**MEMORANDUM**

**To:** Design Review Board  
**From:** Scott Guter, Planner  
**Date:** April 24, 2017  
**File No.:** DRV17-00181  
**Subject:** **VILLAGE AT TOTEM LAKE – ROSS BUILDING  
DESIGN RESPONSE CONFERENCE**

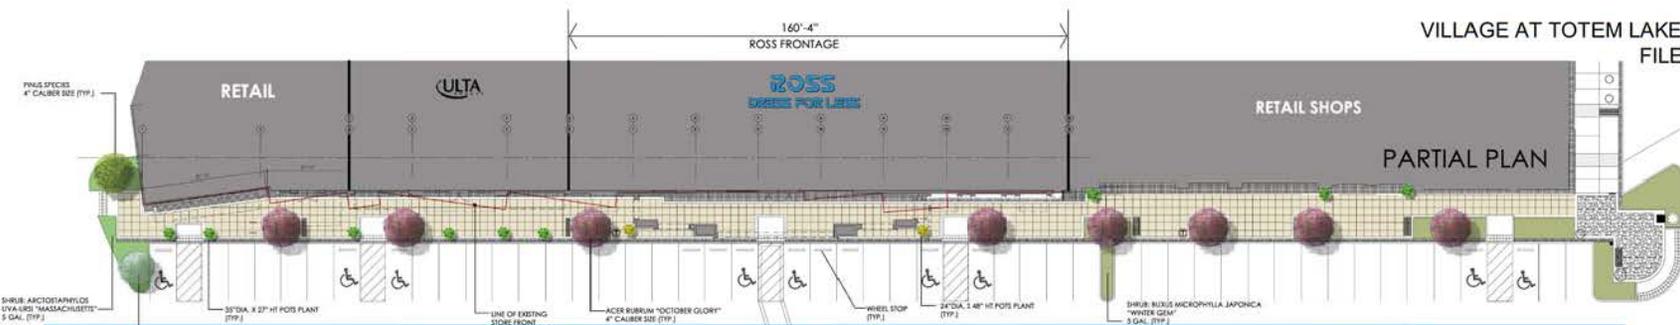
*Staff Comment: The face of the Ross arcade is relatively flat and pillars lack definition. Section drawing AA does not appear to accurately reflect the adjacent building elevation drawing. There is also a lack of contrast both in terms in color and material between the different tenant spaces and associated modulation changes.*

*Staff Comment: The proposed color reads monolithic across the façade and does not reflect design palette of Buildings A, B, and C. See staff comments in the previous section on this topic.*
